## Field campaign

<b>Topic</b>	15MY power boot PDI check (SC15/05)
<b>Market area</b>	Bentley: worldwide (2WBE)
<b>Brand</b>	Bentley
<b>Transaction No.</b>	2039914/1
<b>Campaign number</b>	EA26
<b>Note</b>	
<b>Type</b>	
<b>US code</b>

### 15 MY Continental

Figure 1

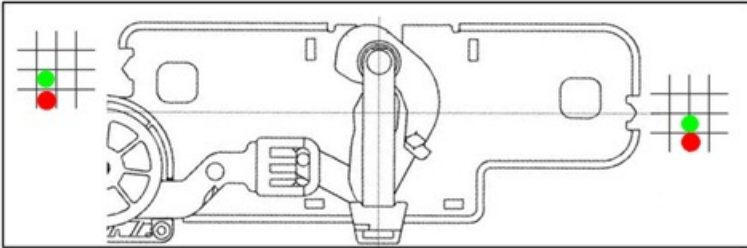
4. Record the position, using attached strikerlatchmarkup.pdf, of the powered striker in relation to the grid stamped into the rear panel (see Figure 1 for example)

5. Mark the starting position of the striker, red dots in example, and then slacken the fasteners securing the striker
6. Adjust the striker vertically upwards in half square increments in reference to the grid lines, tighten the fasteners and re test. Continue adjustment until 3 successful boot latching cycles are observed. Note: The striker plate should be adjusted equally so as to remain horizontal

7. Record the final position of the striker on the grid, green dots in example.
8. Finally torque tighten striker fasteners 20 Nm
9. Refit the boot sill finisher cover. "Refer to Boot aperture finishers - To remove and fit" Rep.Gr.70.
